febi 39245

Repl. No. 06H 145 710 D

Diverter Valve

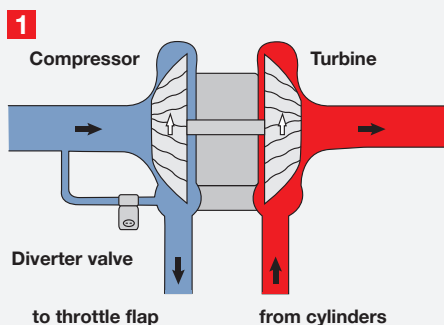
Slow response behaviour during load changes and gradual loss of power may be signs of a faulty diverter valve.

The diverter valve (DV) ensures a rapid drop in pressure on the compressor side to prevent the turbocharger being slowed down unnecessarily if the throttle flap closes suddenly – thus reducing the “turbo lag” effect. (see Fig. 1).

the valve’s slow switching times also prevent the dynamic pressure downstream of the compressor from reducing which consequently creates the “turbo lag” effect. This not only results in unnecessary slowing down of the turbocharger but also places an enormous load on the closed throttle flap and the turbocharger’s turbine end.

febi recommends replacing the diverter valve with the most up-to-date version (febi 39245). As a piston version (see Fig. 3), the piston ensures that the valve functions perfectly.
